Village of Cassopolis

CWSRF Interceptor Force Main Replacement

ADDENDUM 1

June 12, 2026

Sheet SR-8.3 – N. Mill Street Surface Restoration Plans Sta. 0+00 to 10+00

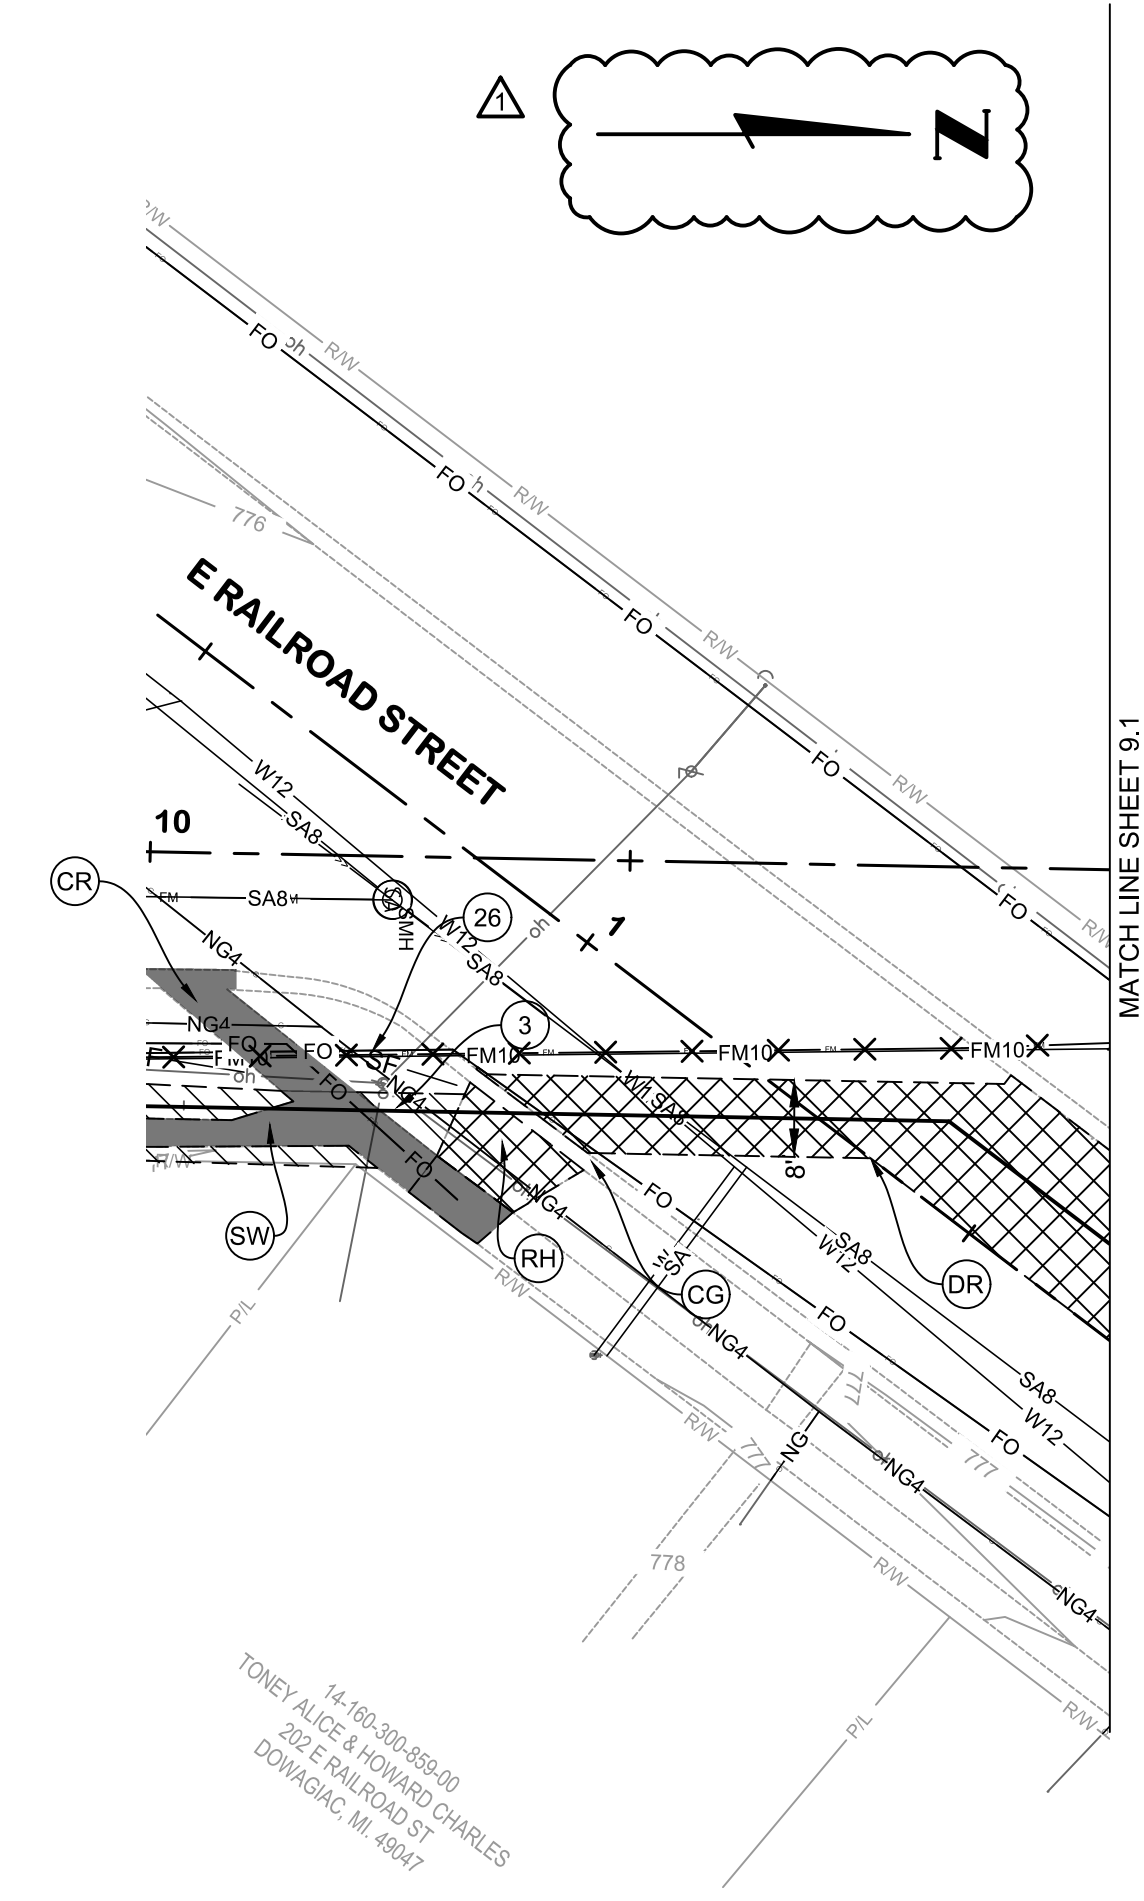
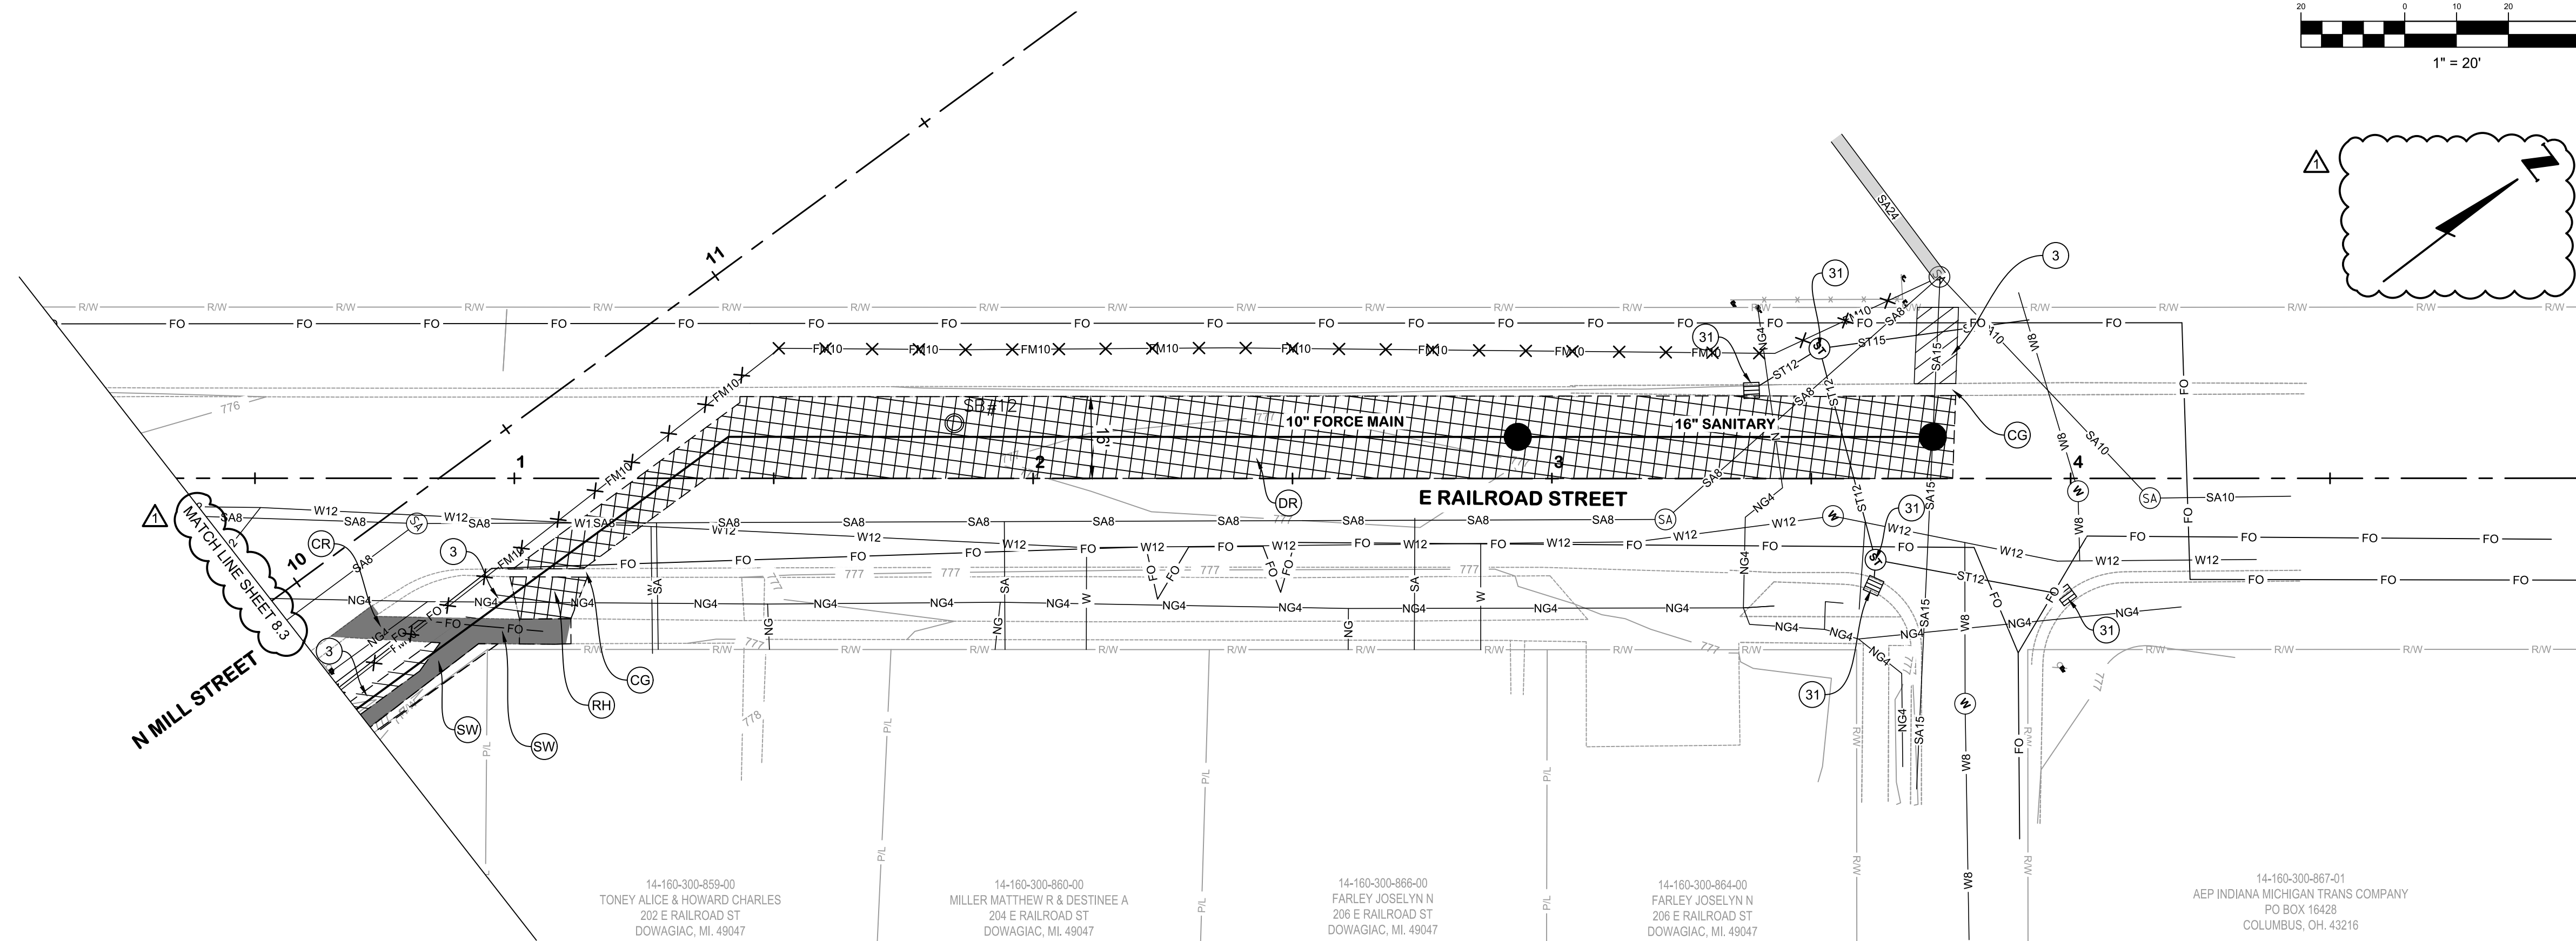
A match line as well as a north arrow were added on this sheet. Replace the sheet with the provided Sheet SR-8.3 included with Addendum 1.

NOTE:
 1. A MATCH LINE, SURFACE RESTORATION HATCH LEGEND AND A NORTH ARROW WERE ADDED ON THIS SHEET. REPLACE THE SHEET WITH THE PROVIDED SHEET SR-8.3 INCLUDED WITH ADDENDUM 1.
